BRITISH MUSEUM PERIMETER PROPERTIES

38 RUSSELL SQUARE

DESIGN AND ACCESS STATEMENT AND ARCHITECTURAL PROPOSALS
Addendum February 2020

SECTION BB

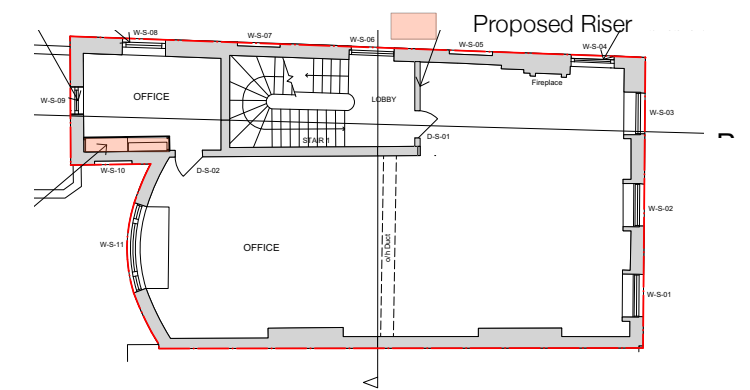
Above: Spine wall distribution showing avoidance of beams and existing cornice, discounted during consultation with LB Camden Conservation Officers

The design team has worked with Camden conservation officers and developed the preferred proposal for a new riser location. This option consolidates all risers within the stair cores the enlargement of the existing risers and the installation of a new riser only affects cornice work already disturbed and replaced during the 1980s alteration works.

Ground Floor

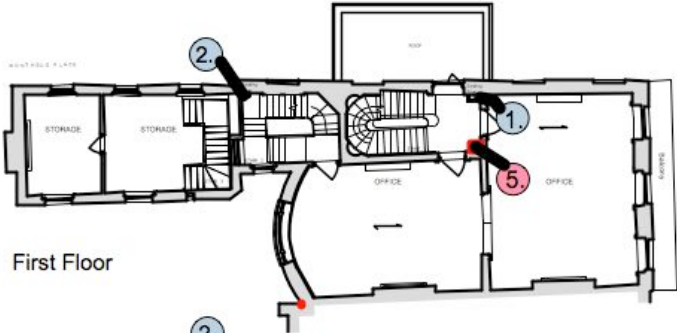
- Change: existing services risers to be reused and required enlargement to be kept to a minimum.
- Change: cornices and skirtings to be reinstated where interrupted by removed partitions and new riser. Profiles to match existing.
- Omit: reference to mechanical and electrical risers concealed within joinery in ‘nibs’ in the main office space.
- Add: new riser to be run within the stairwell symmetrically with the adapted riser on the opposite wall.
- Omit reference to bespoke joinery covers to heating and cooling system.

First Floor

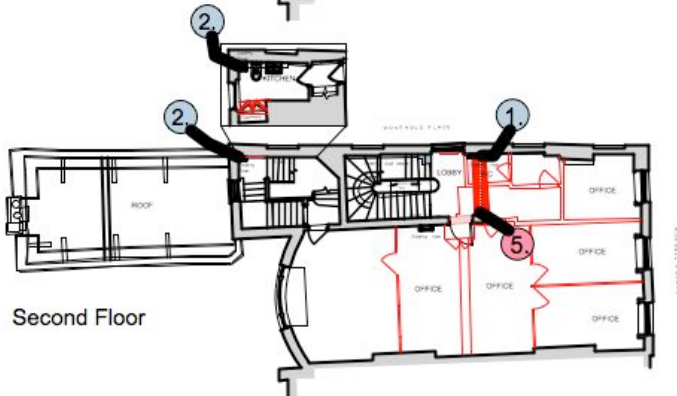
- Change: existing services risers to be reused and required enlargement to be kept to a minimum.
- Change: cornices and skirtings to be reinstated where interrupted by removed partitions and new riser. Profiles to match existing.
- Omit: mechanical and electrical risers concealed within joinery in ‘nibs’ in main office space.
- Add: new riser to be run within the stairwell symmetrically with the adapted riser on the opposite wall.
- Omit reference to bespoke joinery covers to heating and cooling system.

Second Floor

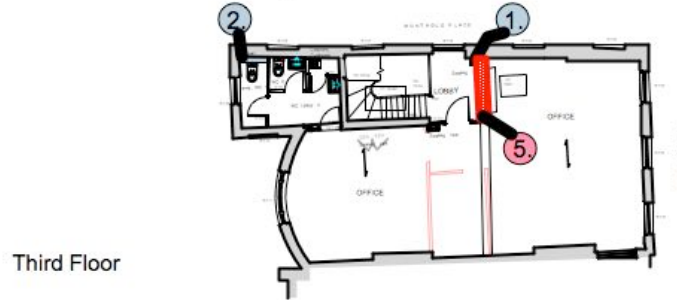
- Change: existing services risers to be reused and required enlargement to be kept to a minimum.
- Omit: reference to mechanical and electrical risers concealed within joinery in ‘nibs’ in the main office space.
- Add: new riser and access for distribution boards to be run within the new wall construction between the stairwell and front office
- Omit reference to bespoke joinery covers to heating and cooling system.

Roof and Loft Level

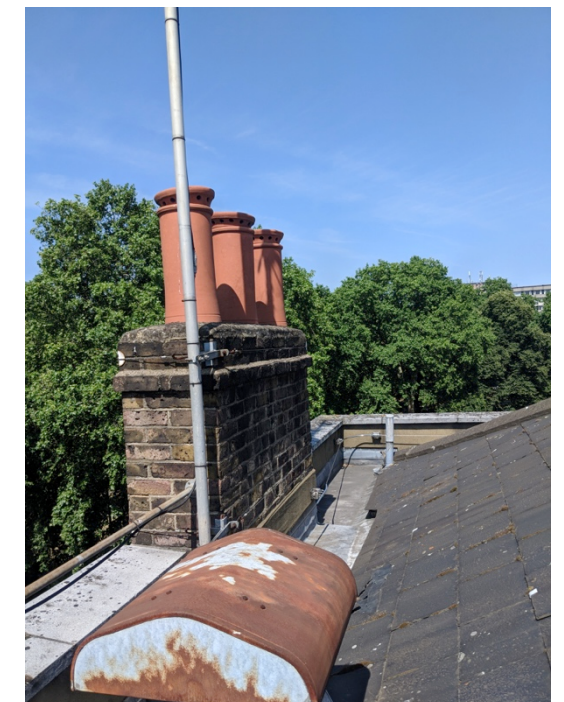
- The main roof is accessible via a hatch in the ceiling on the 3rd floor at the top of the main stair hall. It is recommended that a new retractable ladder is fitted to improve access. It is advisable to improve safe access to the outer edges of the roof by extending and refurbishing a Man Safe cable-based fall protection system. This should afford safe access to all areas of the roof. Where the system is fixed, strengthening of the roof/ parapet wall structure may be required.

- New ventilation slates are to be included on the inner pitches of the roof to match the existing vent slates on the outer pitches and provide suitable cross ventilation in the roof void which currently is non-existent.

- Remaining plant footings to be removed. Flat roof surface to be repaired or overlaid with new membrane applied over asphalt flat roofing surface.
- Perimeter metal balustrade to be replaced with new.

Above: Existing concrete plinths on flat roof area to be removed.
